DESIGN REVIEW COMMITTEE MEETING

4.I. 3637 Elm Street Addition

4.II. 3558-3668 Elm Street New Multi-Family Construction

DEPARTMENT OF PLANNING AND ZONING
PLANNER'S REPORT

PROPOSED FLOOR PLAN -
ELECTRICAL LOWER LEVEL

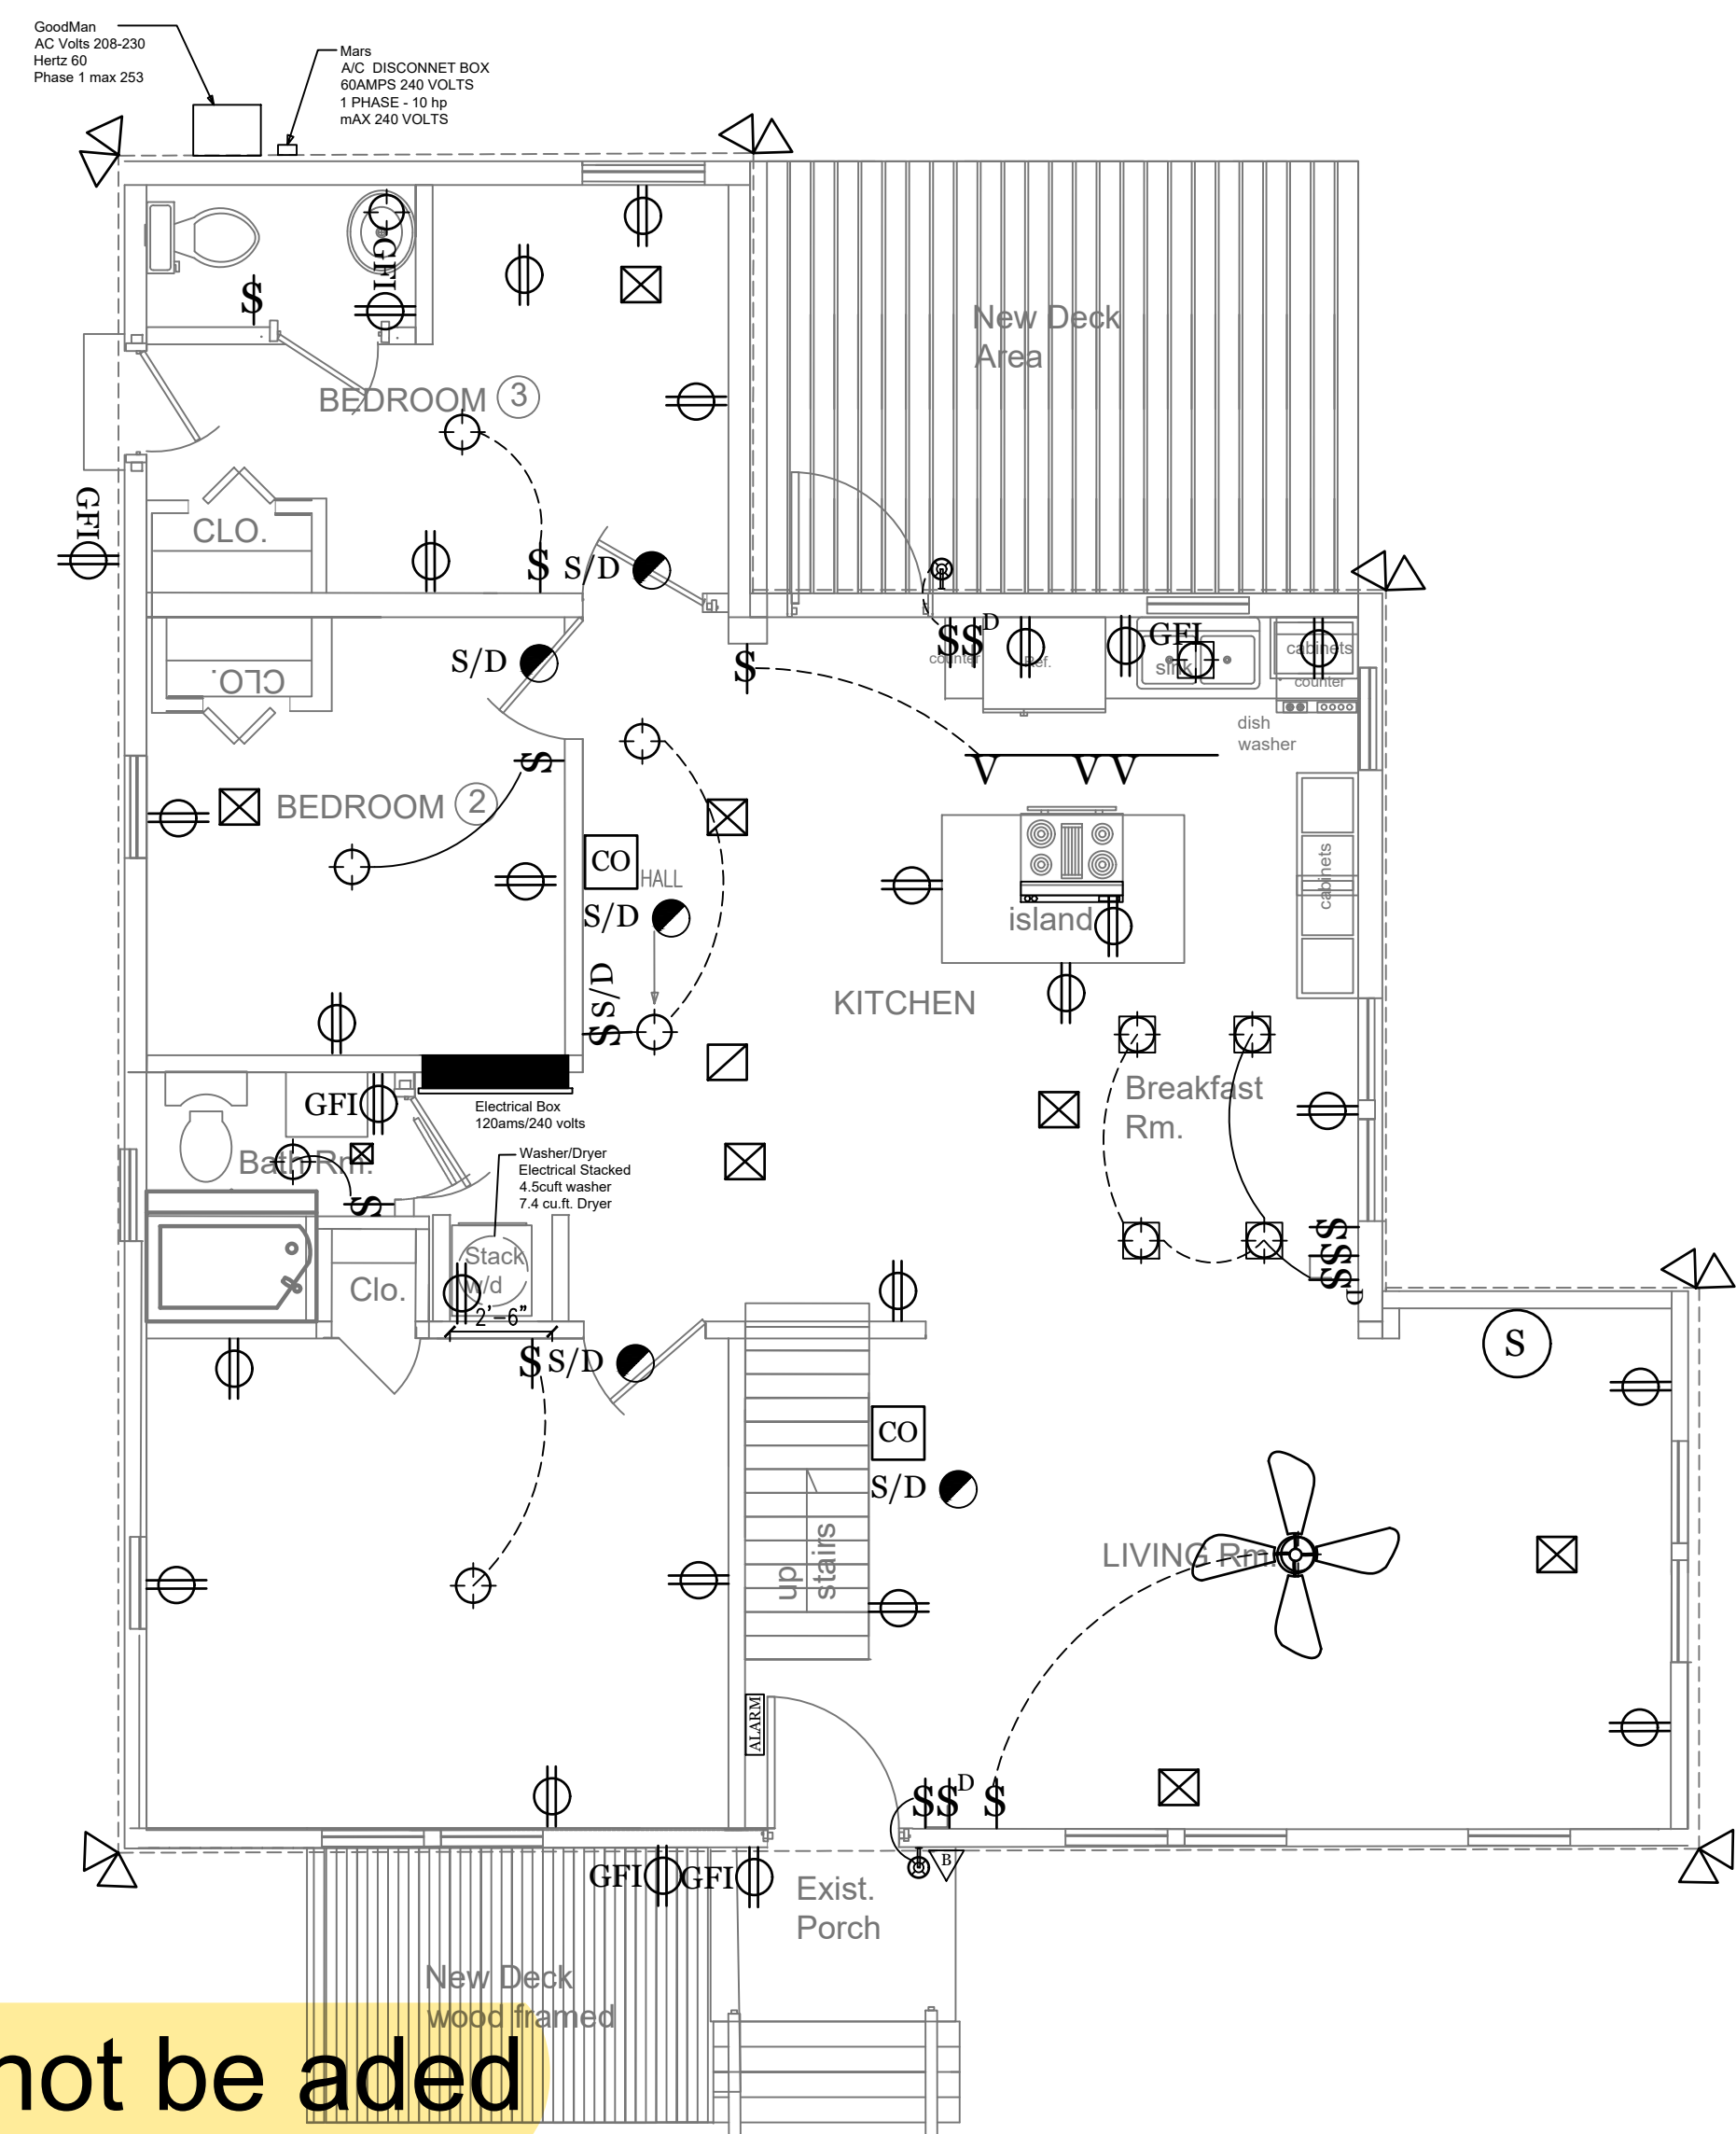
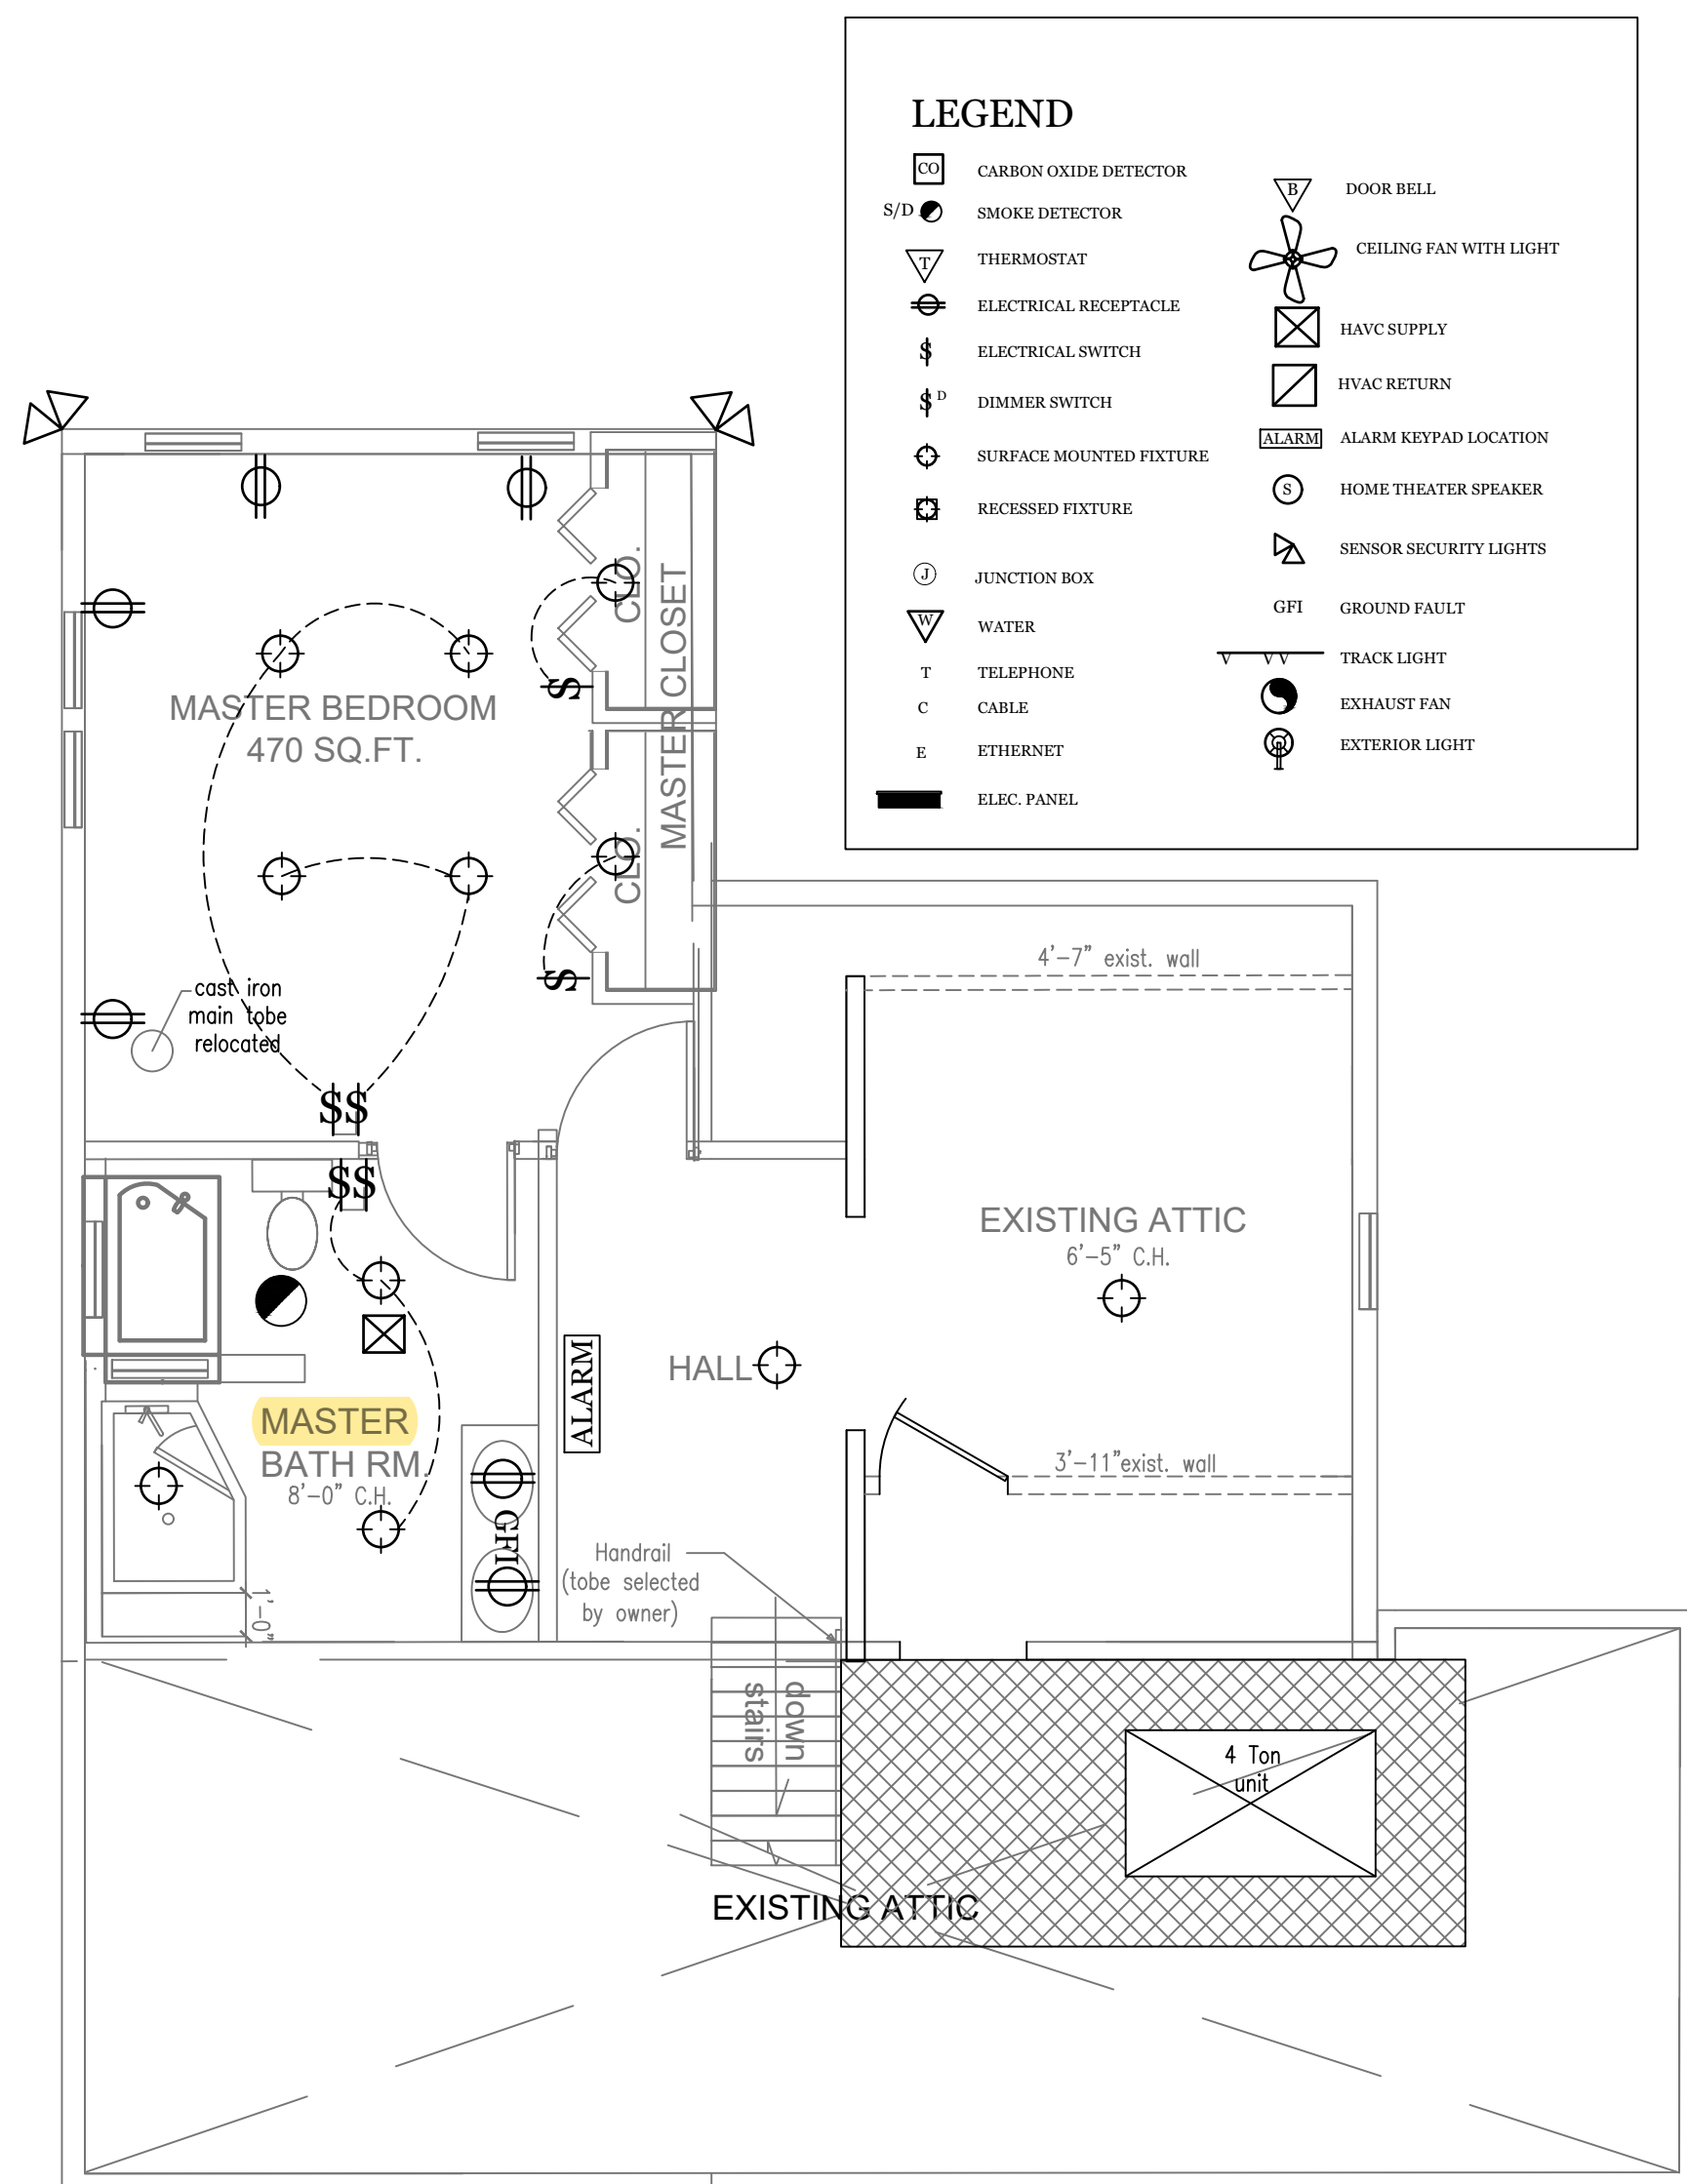
Deck will not be added
